Historical Affairs and Landmark Review Board

HALRB Case 14-09 (HP1400014)

A request by Arlington County Public Schools, the owner of 5800 North Washington Boulevard in the Swanson Middle School Historic District, to remove and replace six round arched windows (approximately 5'x12').

CERTIFICATE OF APPROPRIATENESS STAFF REPORT

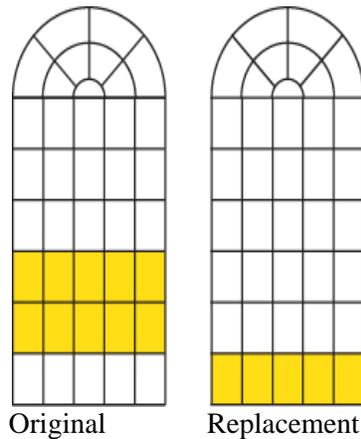
The proposed steel replacement windows will match the design of the existing steel windows, but differ in operability as the proposed hopper window is in a different location and height. The operable portions of the window are colored yellow on the drawing below.

The DRC asked that this case be placed on the discussion agenda for the November 19, 2014, HALRB meeting, but recommended approval of the true divided light steel windows. The DRC stated that the approval of simulated divided light windows in lieu of true divided light windows due to overall costs could be addressed by the full board. The DRC requested full cost estimates be provided for the full Board. In addition, the DRC asked the applicant to include existing dimensions/details including profiles of the muntins.

representative stated that the simulated lights have an integral bevel and are fully welded into the perimeter frame. Due to the additional costs of true divided light windows, staff recommends the approval of simulated divided light steel windows with internal muntin spacer bars to create effective shadow lines. Staff finds that the request meets the intent of the *Swanson Middle School Design Guidelines* and the *Secretary of the Interior's Standards for Rehabilitation* (Standard #6).
